DICK'S SPORTING GOODS ET AL (UP DEV. E. COLONIAL UNIT 2 REPLAT)

Applicant's Request: The applicant propos-
es to replat a vacant commercial property pre-
paratory to constructing a Dick's Sporting
Goods store and a restaurant on the property.
The property is located in the Colonial Town
Center neighborhood.

Staff Recommendation: Approval of the
Minor Plat, subject to conditions in this staff
report.

Updated: February 28, 2014

PROPOSED PLAT

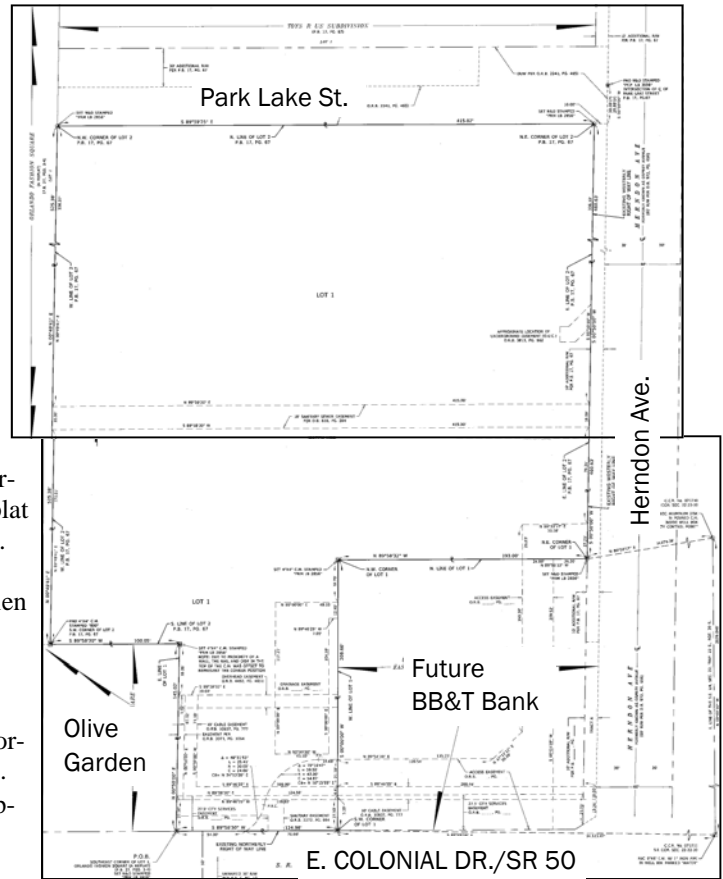
1. The notary block in the dedication is set up for a municipal corporation. It must be corrected and set up for the LLC (owner).
2. The missing information (blank lines) within the legal description must be added. As well as any missing information indicated on the plat.
3. "City of Orlando" must be added to the subtitle.
4. The easement recorded in DB 818/289, is shown on the certificate of title but not on the plat or in the plat notes.
5. Upon approval of all depts., the dedication and qualification statement must be properly executed.
